GS# 103-317
University Pointe – Buildings 100 & 200
Jackson State University
Project Number: 2017-006

Addendum No. 2

14May2026

A-502

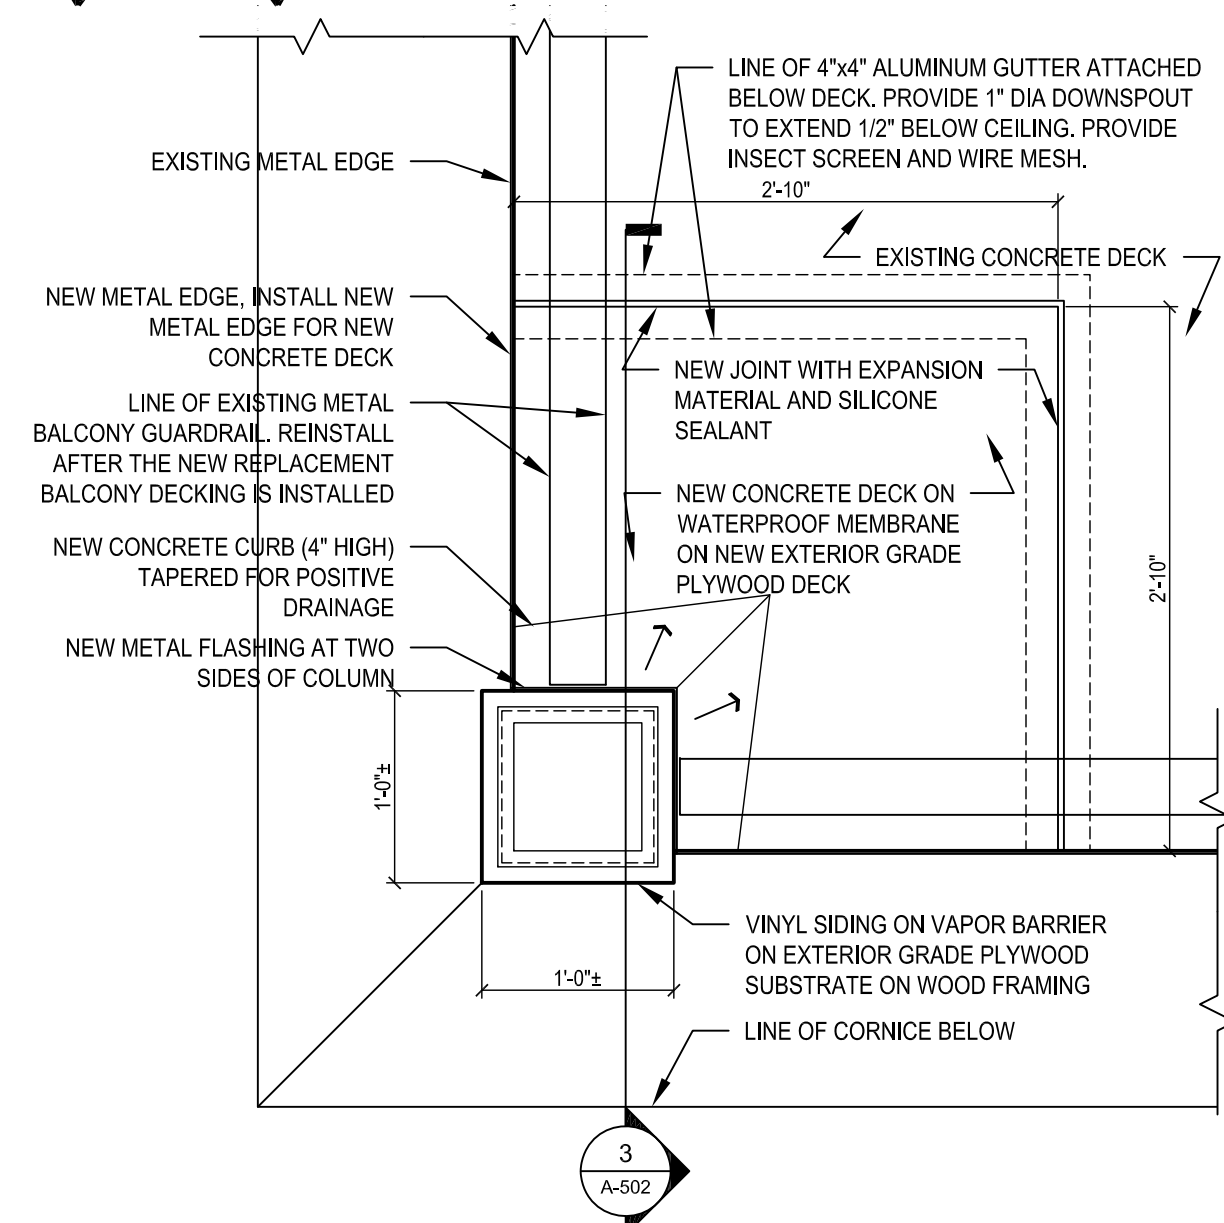
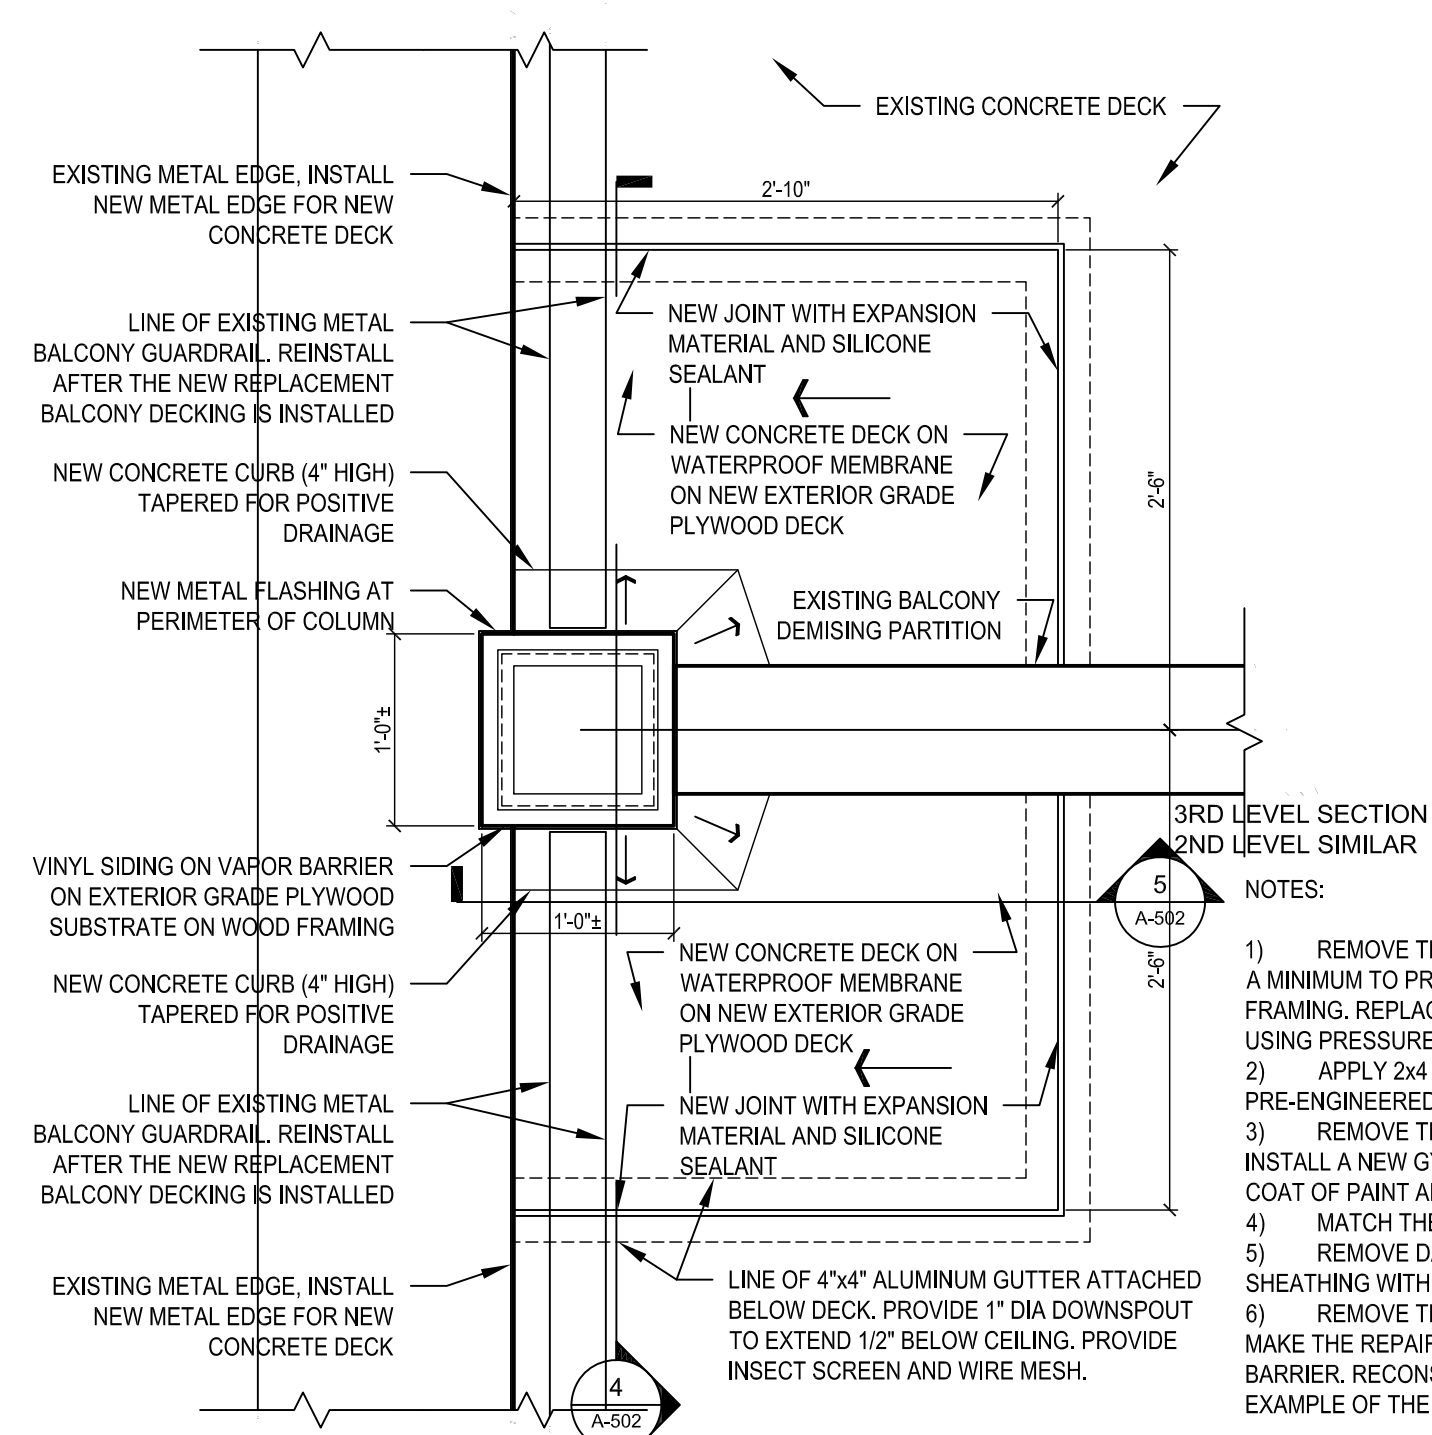
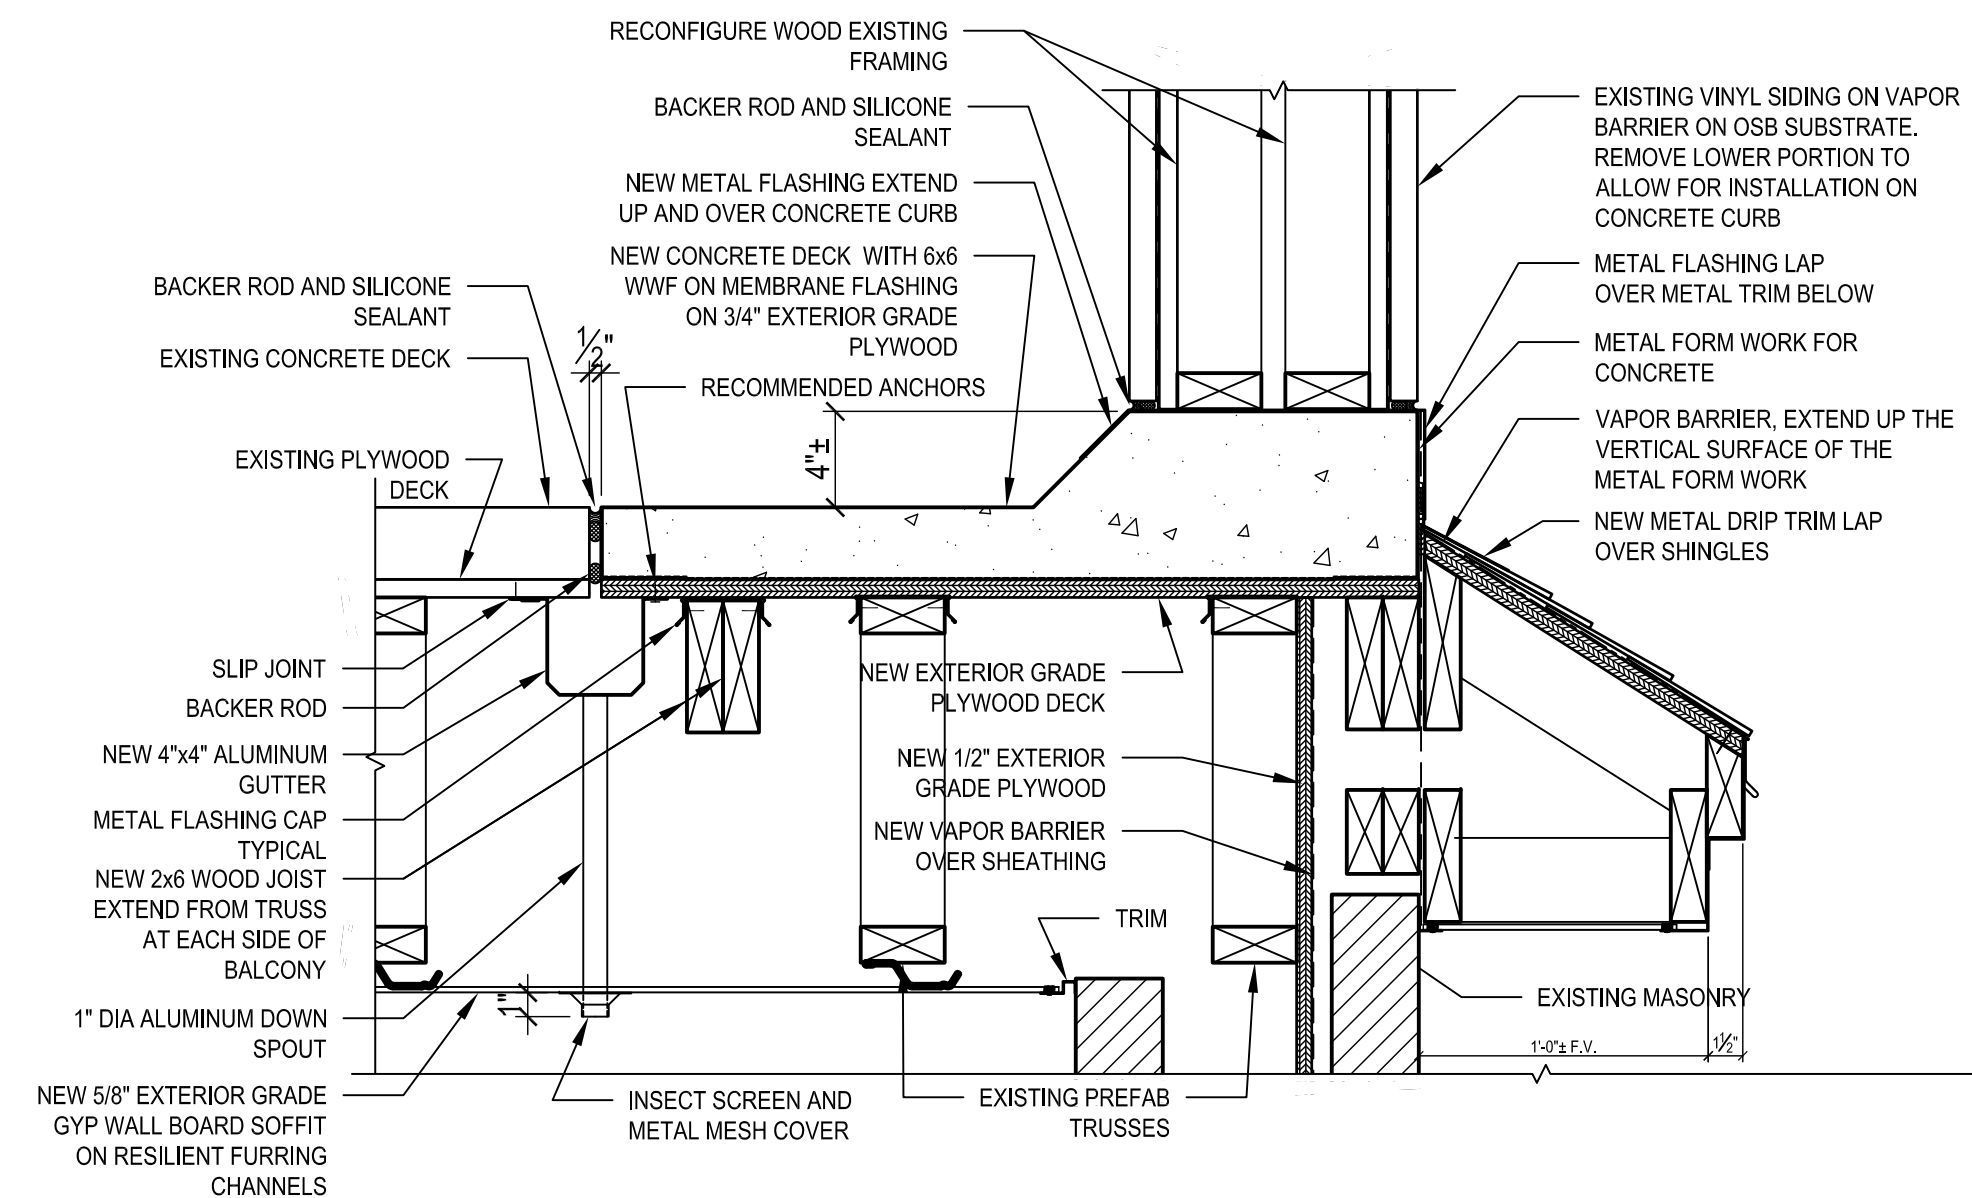
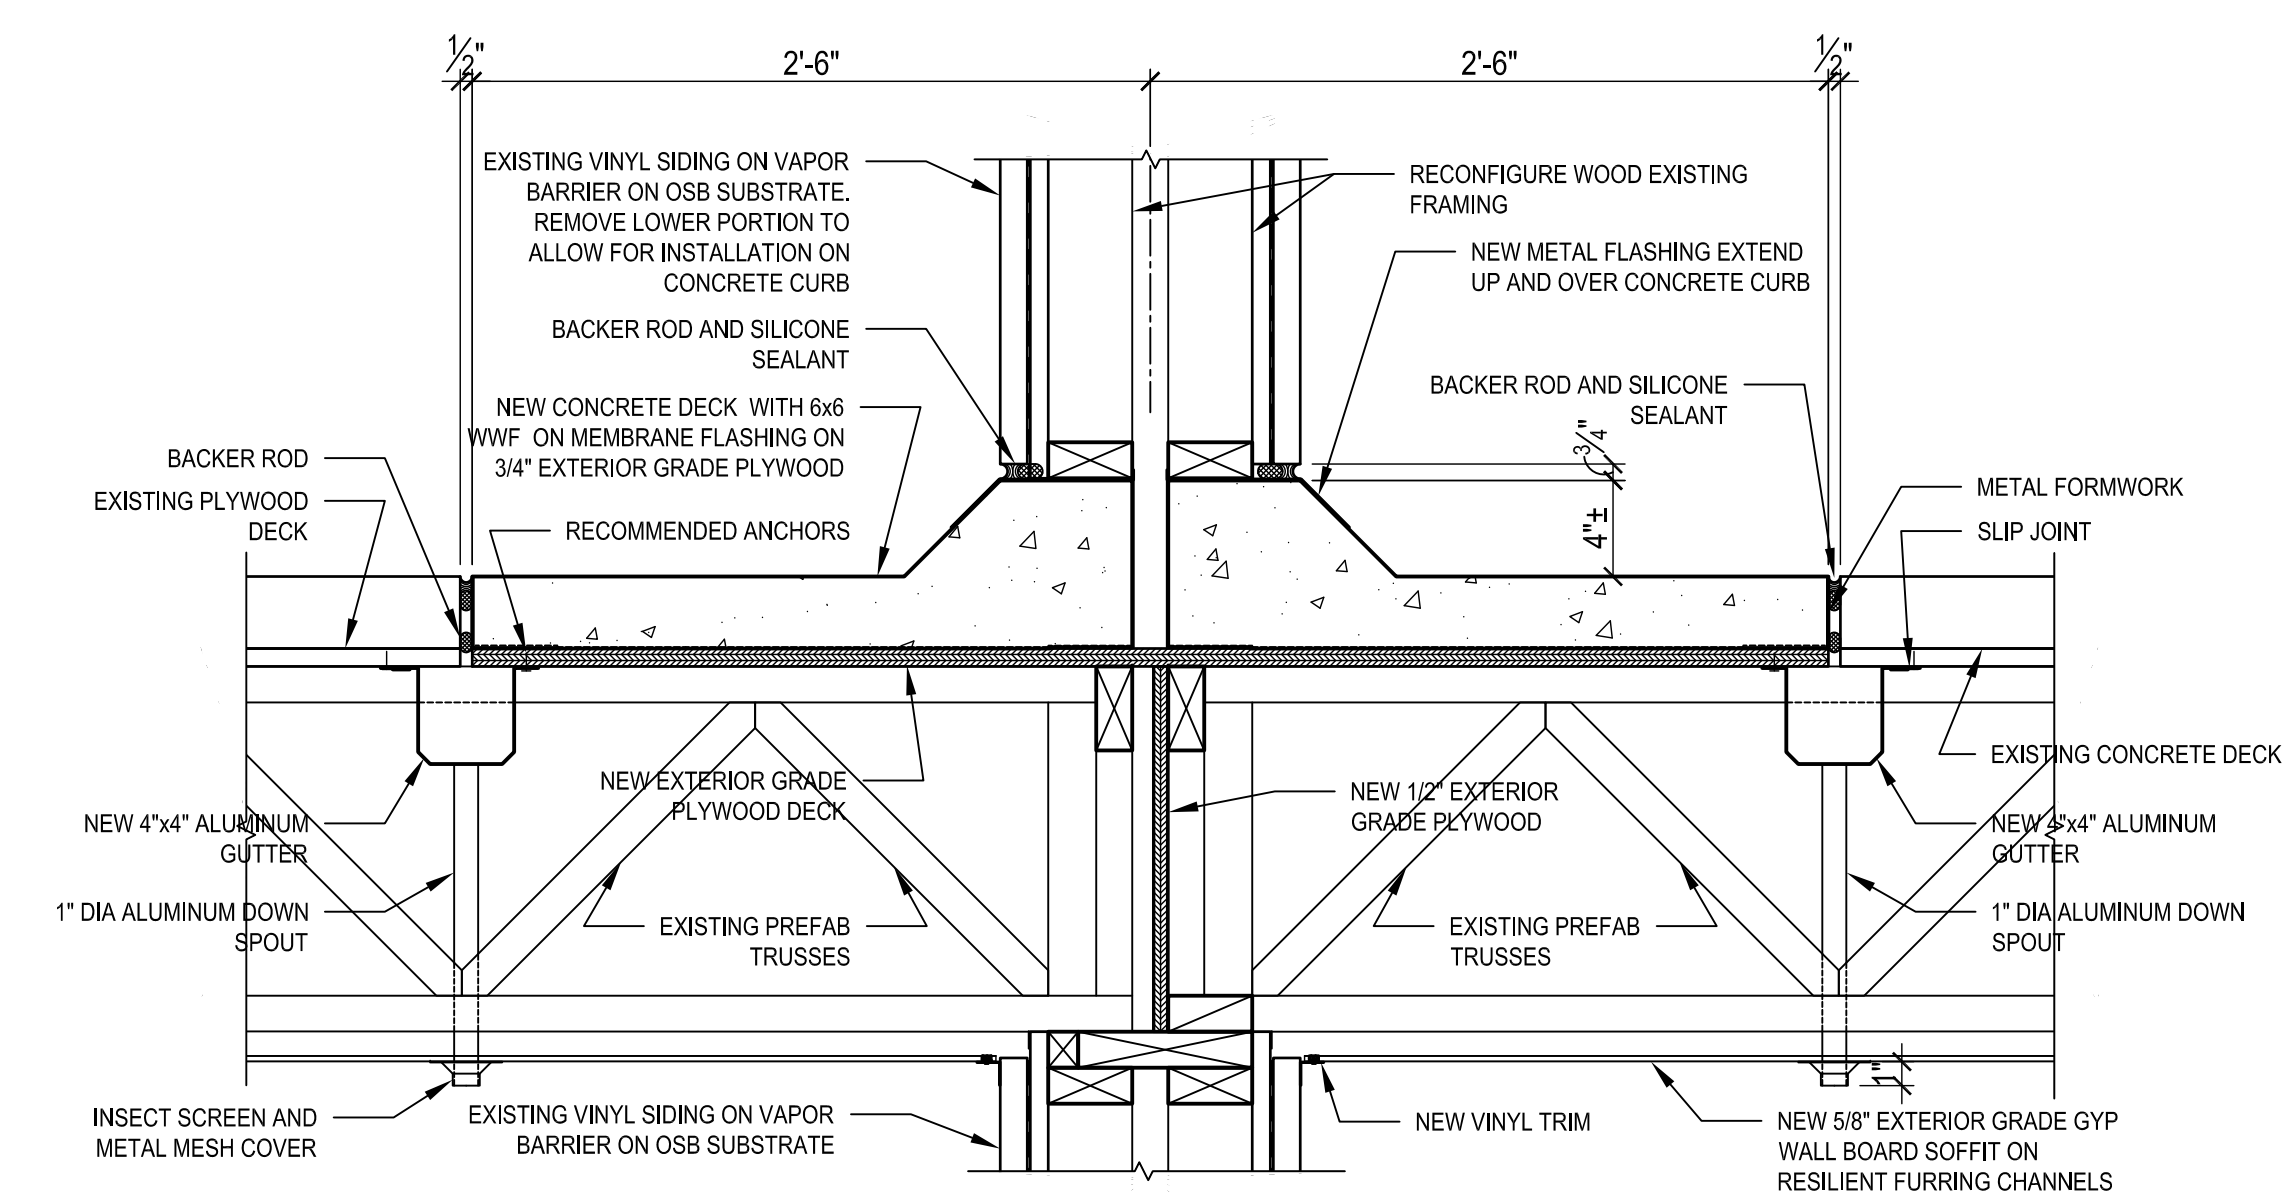
- Response: Yes. Remove all of the existing insulation and install new insulation. Current code mandated "R" values and STC ratings shall apply.
- Item No. 17 Water damage was observed at the west balconies of Building 200 (see attached photos). The plans do not indicate work to be performed at these locations or the extent to be done. One location where the soffit was removed you could clearly see rot and damage to the floor decking above and the wall studs. Repairing this particular location would require removing the concrete topping on the balcony above to replace the substrate. It is unknown if this would be required or not at the other locations or if the floor trusses might need repaired at the other locations. Please clarify what is to be done at these locations.

- Response: Details which will be representative of the as-built conditions are provided as part of this addendum (drawing sheet A-502). The soffits are to be removed in their entirety and replaced. The concrete decks shall be cut and removed per the details. Damaged OSB sheathing, vapor barrier and plywood and 2"x framing shall be replaced. Damaged wood decking and vertical sheathing shall be replaced with exterior grade plywood with a membrane waterproofing barrier applied between substrate decking and new concrete (install 6x6 WWF in the new concrete). Install supplemental wood framing at the trusses as needed to maintain stability.

- Retrofit work shall be applied at **all** balconies (east and west facades) for the second and third floors.
- Alternate balcony concrete substrate: Galvanized (9/16" thick) Type "S" Form Deck – 26 gauge. Submit cost difference for comparison.

- NOTES:
- 1) REMOVE THE EXISTING CONCRETE TO THE LIMITS SHOWN AS A MINIMUM TO PROVIDE ACCESS TO THE COMPROMISED WOOD FRAMING. REPLACE THE DAMAGED 2"x FRAMING AND REPLACE USING PRESSURE TREATED LUMBER TO MATCH THE EXISTING SIZES.
 - 2) APPLY 2x4 AND 2x6 WOOD LUMBER TO SUPPLEMENT THE PRE-ENGINEERED TRUSSES IF FOUND TO BE COMPROMISED.
 - 3) REMOVE THE EXISTING EXTERIOR SOFFIT IN ITS ENTIRETY. INSTALL A NEW GYP WALL BOARD EXTERIOR SOFFIT. APPLY PRIMER COAT OF PAINT AND NEW PAINT FINISH.
 - 4) MATCH THE THICKNESS OF ALL MATERIAL TO BE REPLACED.
 - 5) REMOVE DAMAGED SHEATHING AND REPLACE WITH NEW SHEATHING WITH VAPOR BARRIER.
 - 6) REMOVE THE CORNICE AT THE SECOND FLOOR BALCONY TO MAKE THE REPAIRS FOR THE FRAMING, SHEATHING AND VAPOR BARRIER. RECONSTRUCT THE CORNICE, SEE DETAIL 3/A-501 AS EXAMPLE OF THE TYPICAL CONDITION.

- NOTES:
- 1) REMOVE THE EXISTING CONCRETE TO THE LIMITS SHOWN AS A MINIMUM TO PROVIDE ACCESS TO THE COMPROMISED WOOD FRAMING. REPLACE THE DAMAGED 2"x FRAMING AND REPLACE USING PRESSURE TREATED LUMBER TO MATCH THE EXISTING SIZES.
 - 2) APPLY 2x4 AND 2x6 WOOD LUMBER TO SUPPLEMENT THE PRE-ENGINEERED TRUSSES IF FOUND TO BE COMPROMISED.
 - 3) REMOVE THE EXISTING EXTERIOR SOFFIT IN ITS ENTIRETY. INSTALL A NEW GYP WALL BOARD EXTERIOR SOFFIT. APPLY PRIMER COAT OF PAINT AND NEW PAINT FINISH.
 - 4) MATCH THE THICKNESS OF ALL MATERIAL TO BE REPLACED.
 - 5) REMOVE DAMAGED SHEATHING AND REPLACE WITH NEW SHEATHING WITH VAPOR BARRIER.
 - 6) REMOVE THE CORNICE AT THE SECOND FLOOR BALCONY TO MAKE THE REPAIRS FOR THE FRAMING, SHEATHING AND VAPOR BARRIER. RECONSTRUCT THE CORNICE, SEE DETAIL 3/A-501 AS EXAMPLE OF THE TYPICAL CONDITION.
